**Economic and Social Council**Distr.: General
3 September 2024

Economic Commission for Europe**Inland Transport Committee****World Forum for Harmonization of Vehicle Regulations****194th session**

1958 Agreement:**Consideration of draft amendments to existing****UN Regulations submitted by GRE****Proposal for the 07 series of amendments to UN Regulation
No. 10 (Electromagnetic compatibility)****Submitted by the Working Party on Lighting and Light-Signalling***

Charging mode configuration for Annex 13

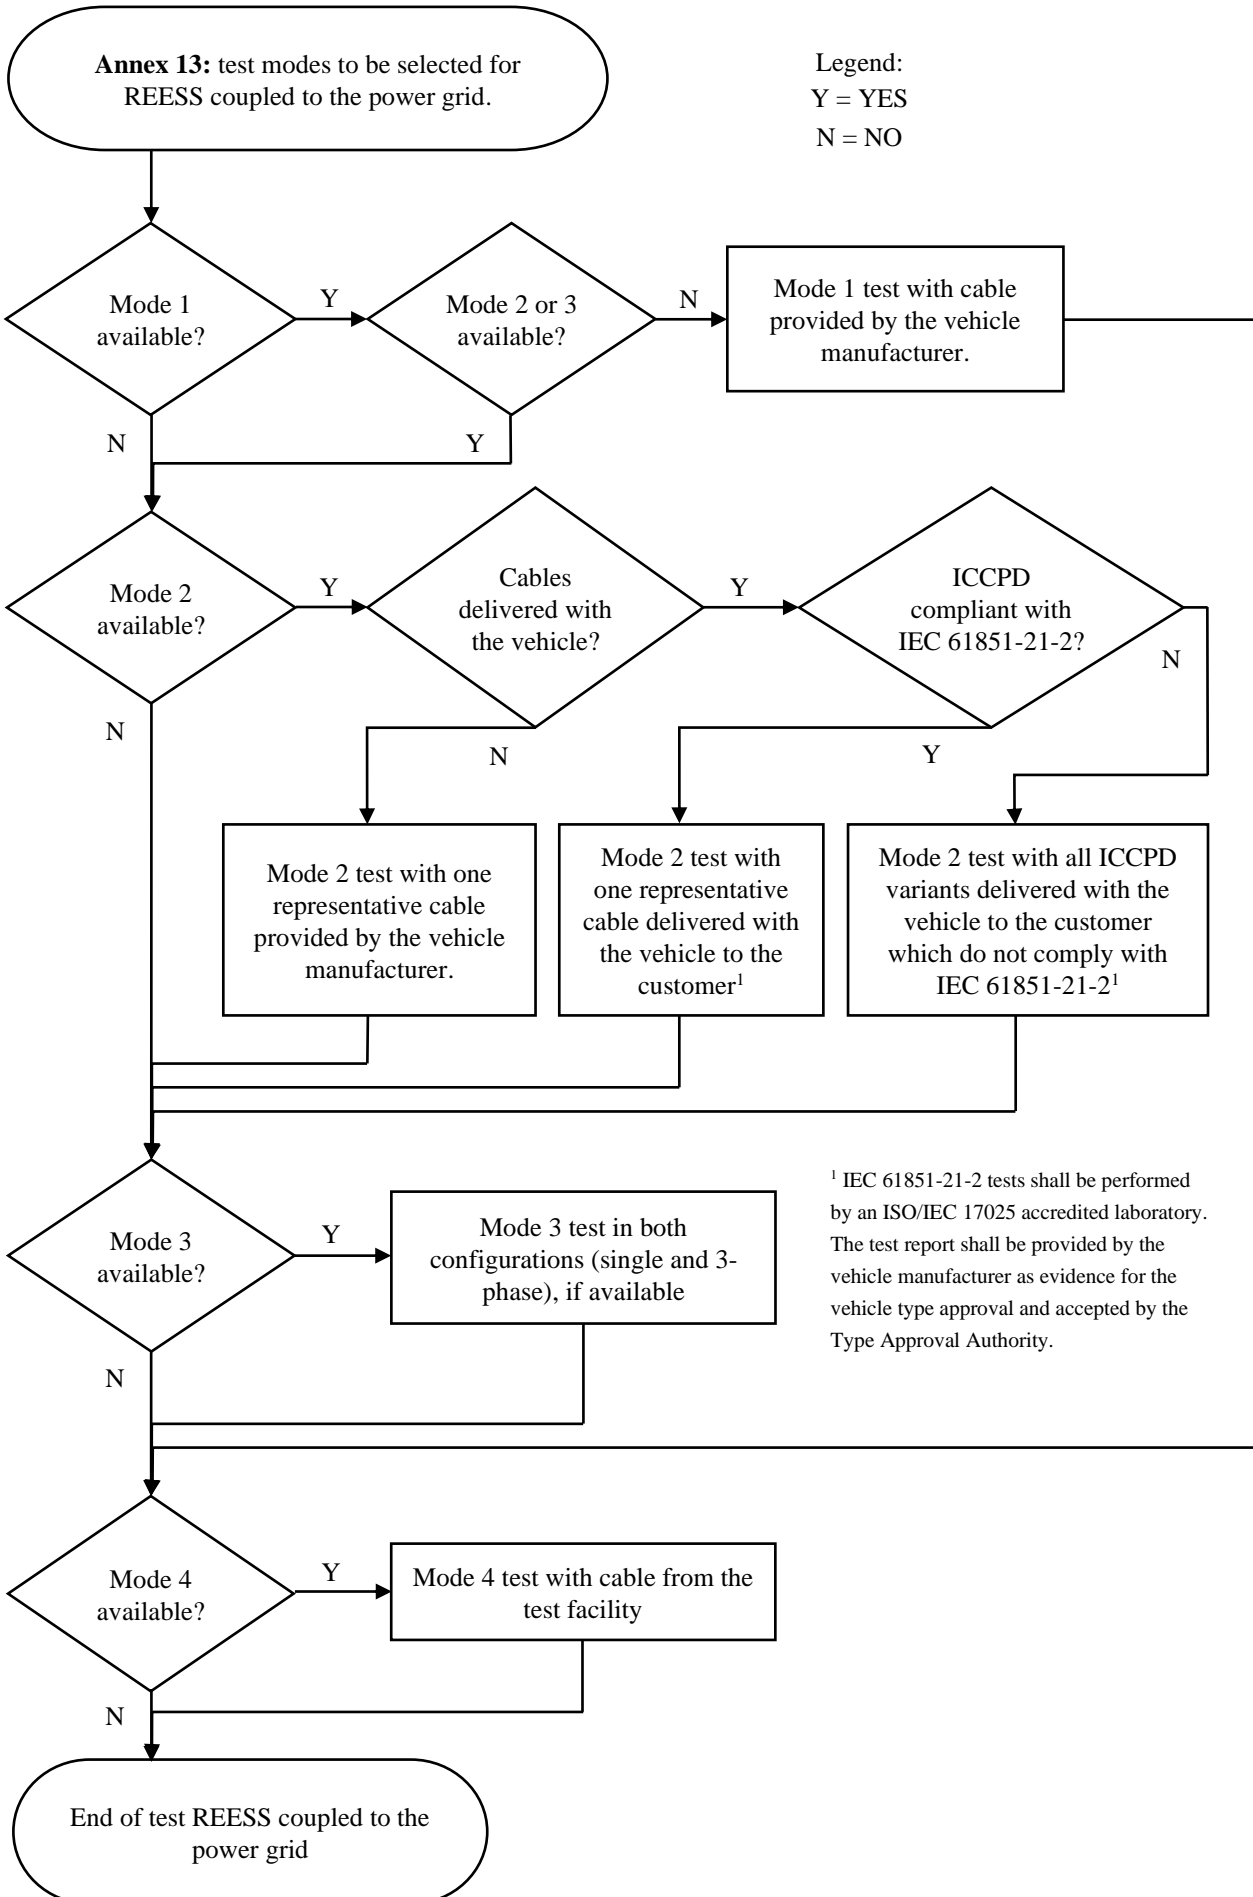
The vehicle shall be tested in the charging mode configuration (if available on vehicle) as defined in flowchart of Figure 1.

The state of charge (SOC) of the traction battery shall be kept between 20 per cent and 80 per cent of the maximum SOC during the whole frequency range measurement (this may lead to splitting the measurement in different sub-bands with the need to discharge the vehicle's traction battery before starting the next sub-bands).

"Figure1b

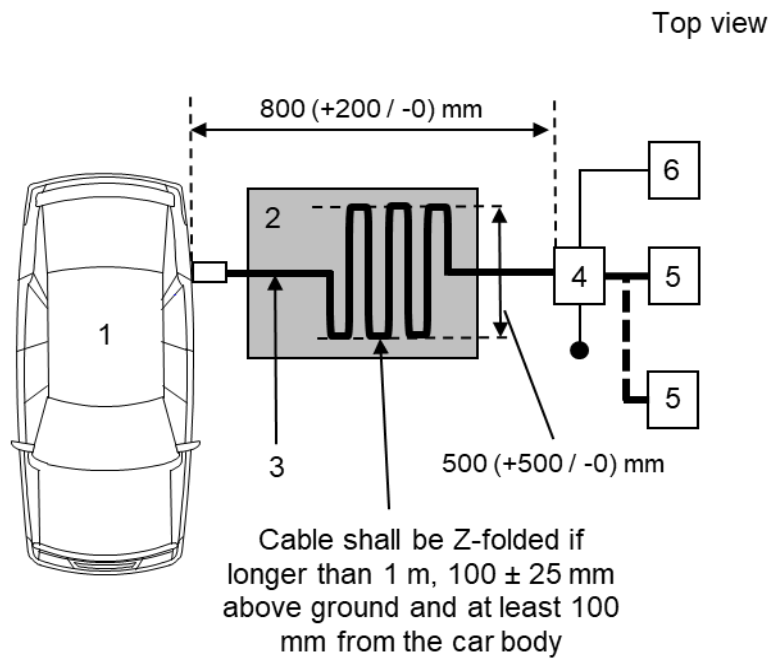
Annex 13, Appendix 1,

Figure 1b, amend to read:

- 1 Vehicle under test
- 2 Insulating support
- 3 Charging harness
- 4 AMN(s) or DC-charging-AN(s) grounded
- 5 Power mains socket
- 6 Measuring receiver"

"Figure 1d

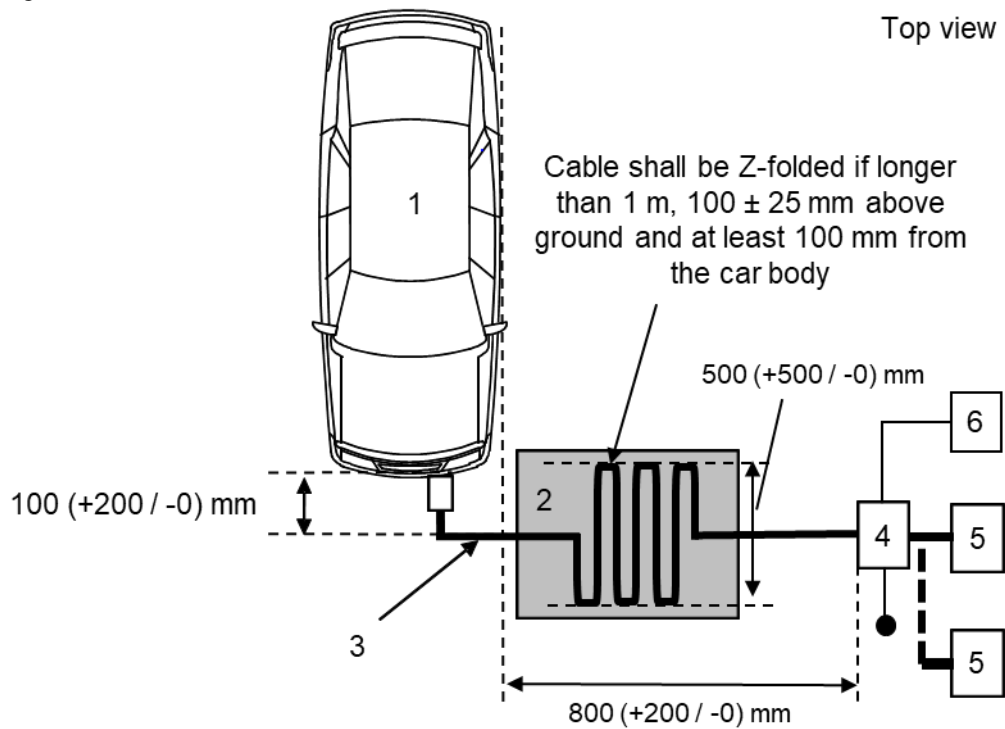
Figure 1d, amend to read:

Charging mode configuration for Annex 15

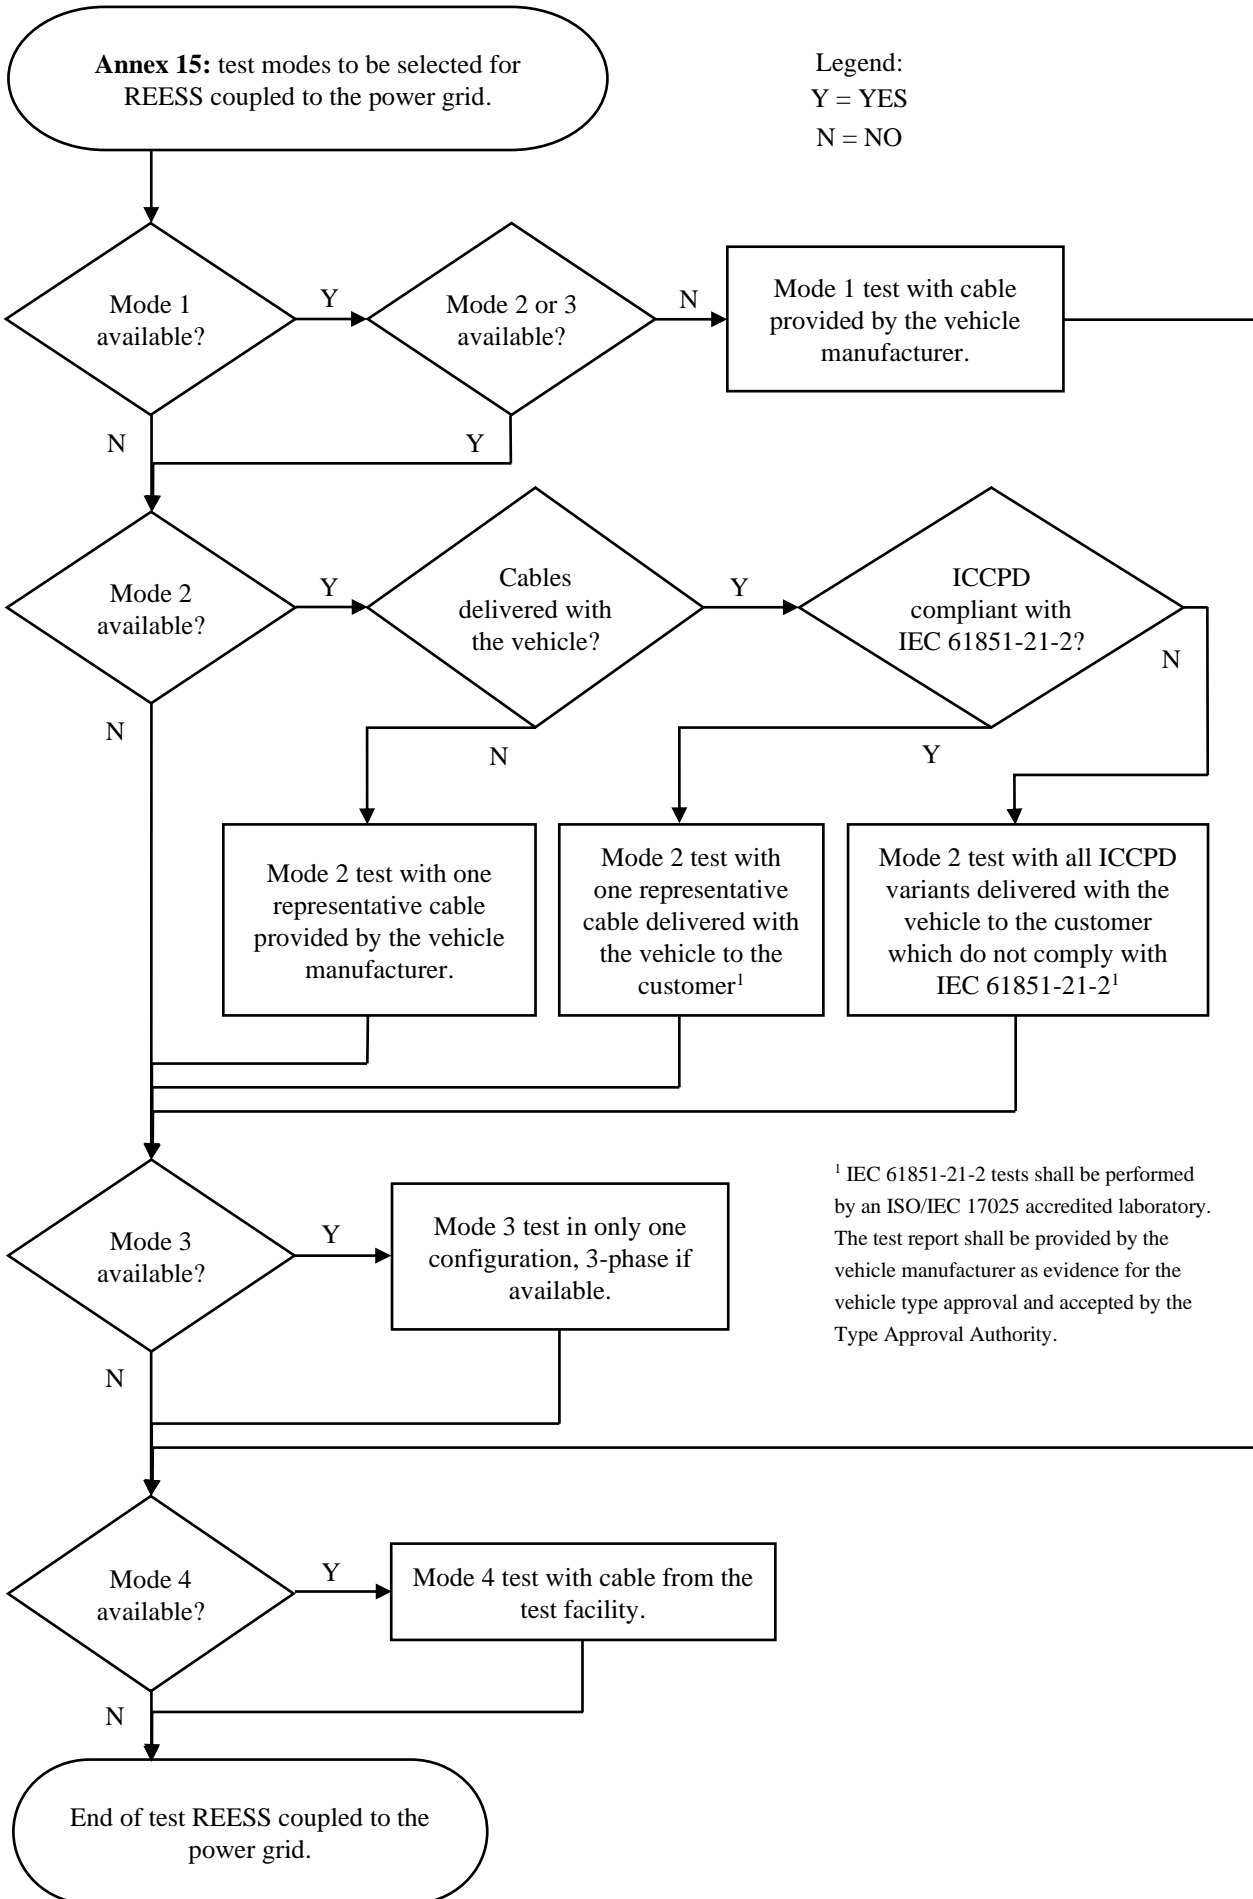
The vehicle shall be tested in the charging mode configuration (if available on vehicle) as defined in flowchart of Figure 1.

"Figure 1d

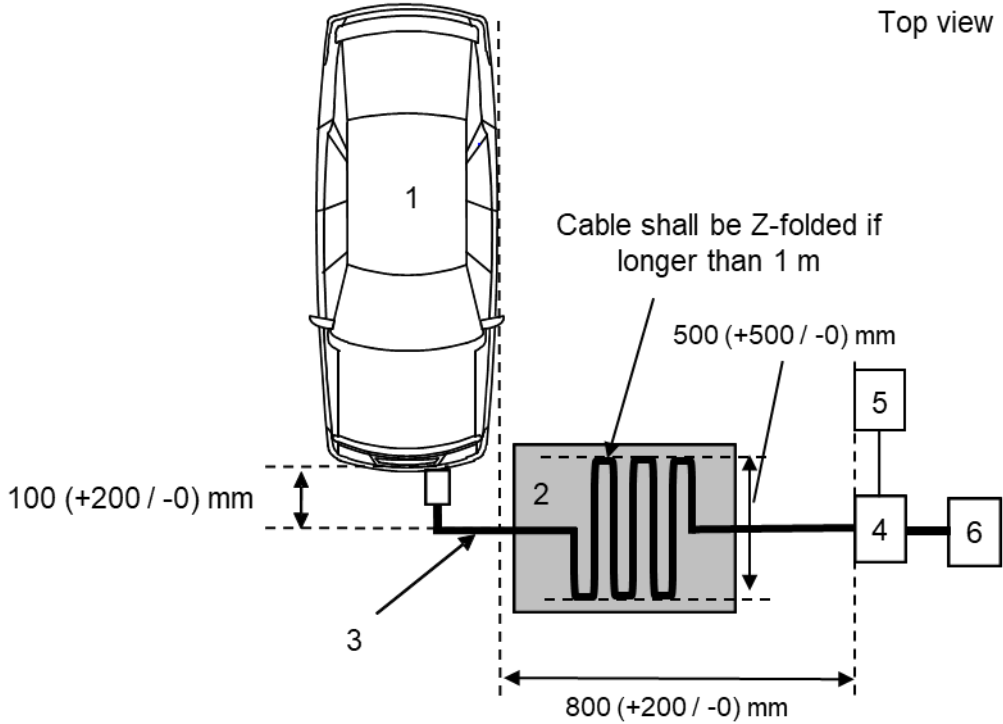
Figure 1d, amend to read:

Figure 1
Charging mode configuration for Annex 16

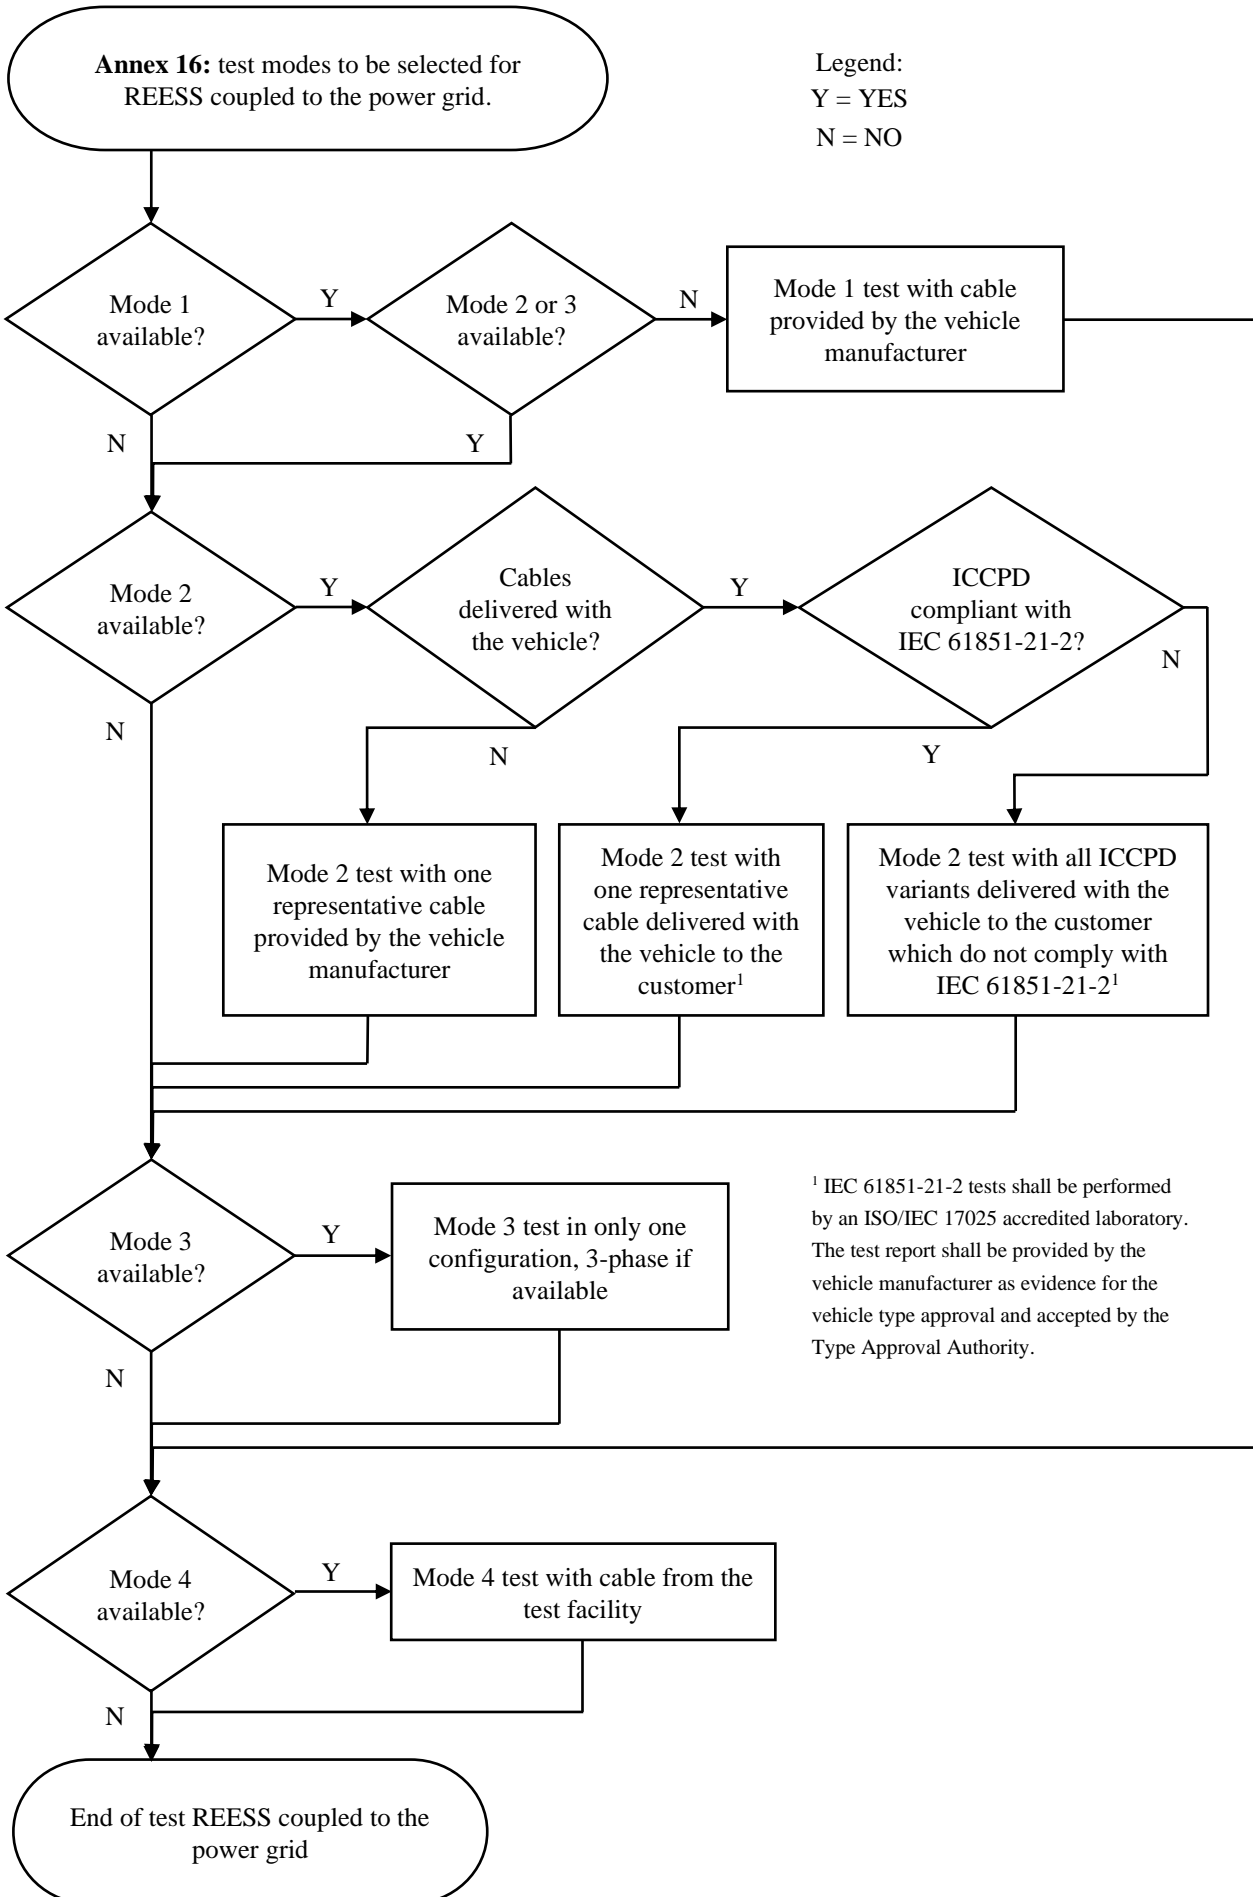
The vehicle shall be tested in the charging mode configuration (if available on vehicle) as defined in flowchart of Figure 1.

"Figure 1b

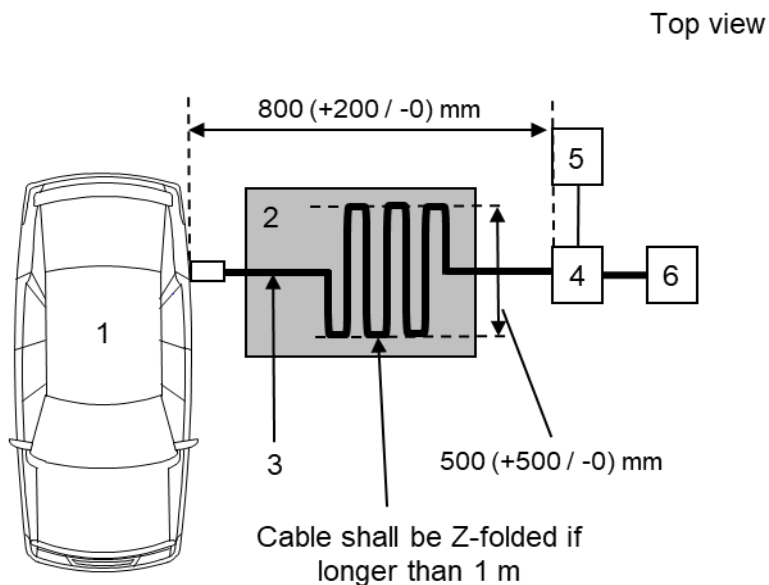
Annex 16, Appendix 1,

Figure 1b, amend to read:

- 1 Vehicle under test
- 2 Insulating support
- 3 Charging harness
- 4 CDN
- 5 Surge generator
- 6 Power supply"

"Figure 1d

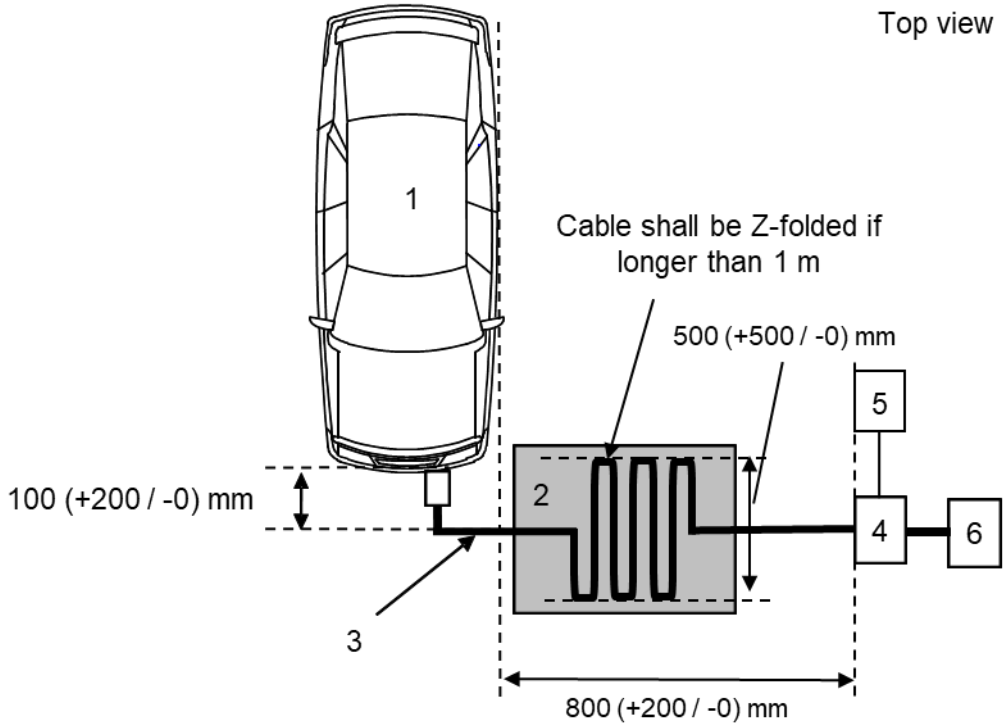
Figure 1d, amend to read:
